Record of Executive Business and Chief Executive's Order

Reg. Reference: SD22B/0137 **Application Date:** 01-Apr-2022
Submission Type: Additional **Registration Date:** 27-Jun-2022
Information

Proposed Development: Demolition of existing single storey extension (35sq.m) and shed (24sq.m) to the rear; construction of single storey extension to the rear and 2 storey extension to side of dwelling; internal alterations; widening of vehicular access at the front of the property.

Location: 184 Butterfield Ave., Rathfarnham, Dublin 14.

Revised Drawings following AI request showing 'Dutch' hip design

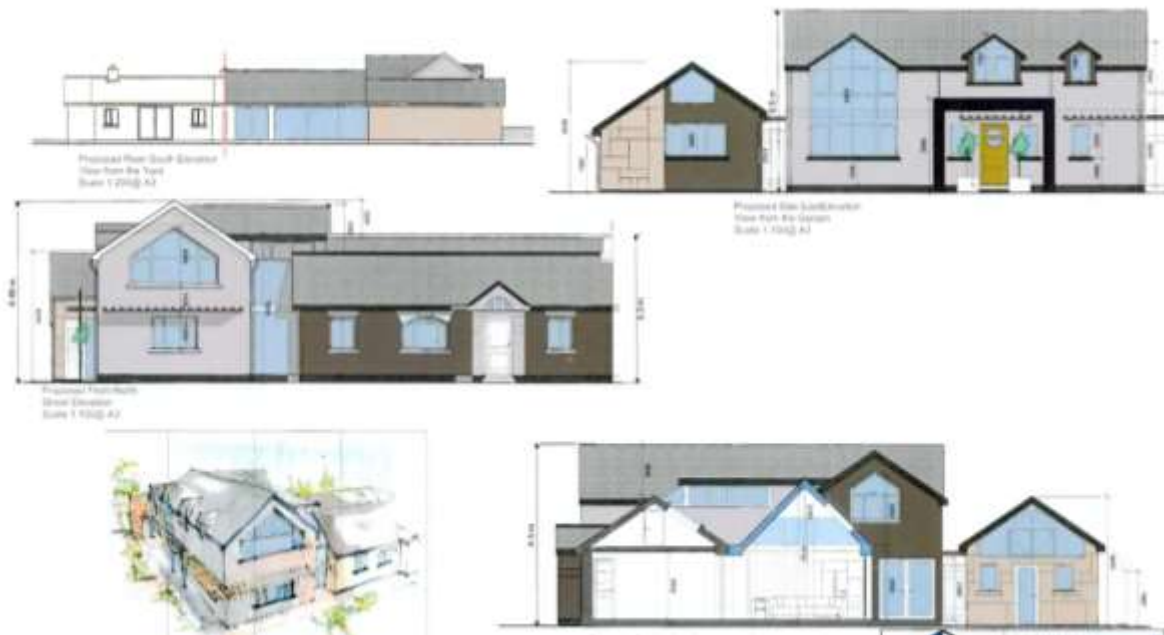
(a). The applicant has submitted revised drawings in an attempt to address the request for additional information. It is noted that Butterfield Drive is labelled incorrectly and should be labelled as Butterfield Park.

The revised drawings submitted show the original gable design for the two storey extension will now be finished in a 'Dutch' hip which will soften the design considerably. The original gable fronted design facing onto Butterfield Avenue will be bookended by another 'Dutch' hip at the opposite end of the two storey extension. The 'Dutch' hip is clearly distinguishable from that of a full pitch gable roof profile and is not 'token' in nature. The Planning Authority considers the applicant has satisfactorily responded to the request for additional information for this item.

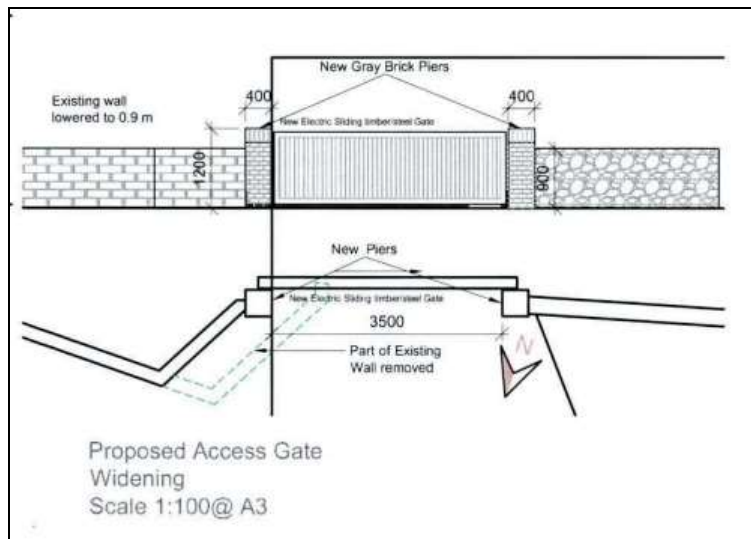
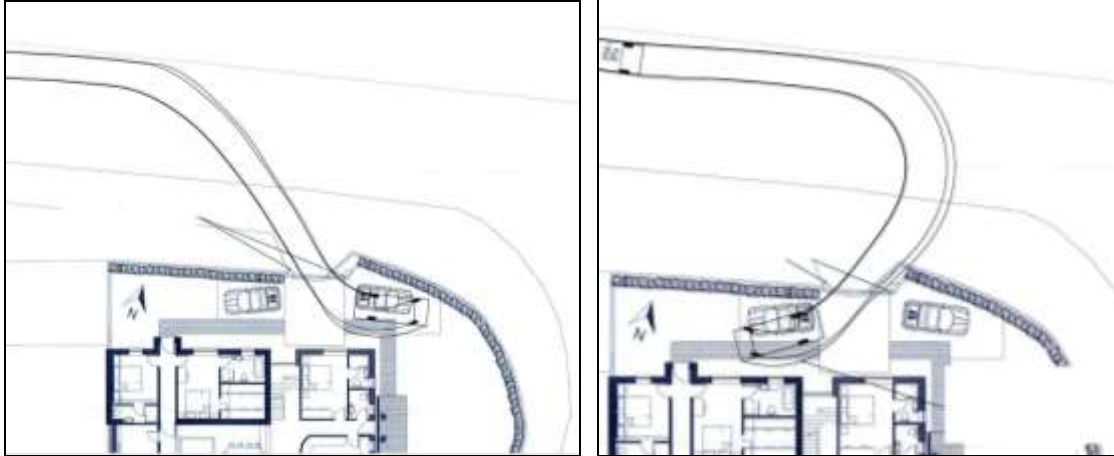
3.(a) The applicant is requested to provide a revised layout showing a 3.5m wide vehicular access with adjacent walls limited to a maximum height of 0.9m, and any boundary pillars limited to a maximum height of 1.2m, in order to improve forward visibility for vehicles. The applicant is also requested to provide a swept path analysis showing how the 2 cars can safely access and egress the parking spaces.

SDCC Roads Department is satisfied with the applicant's submission showing the boundary wall heights and swept path analysis for the proposed access.
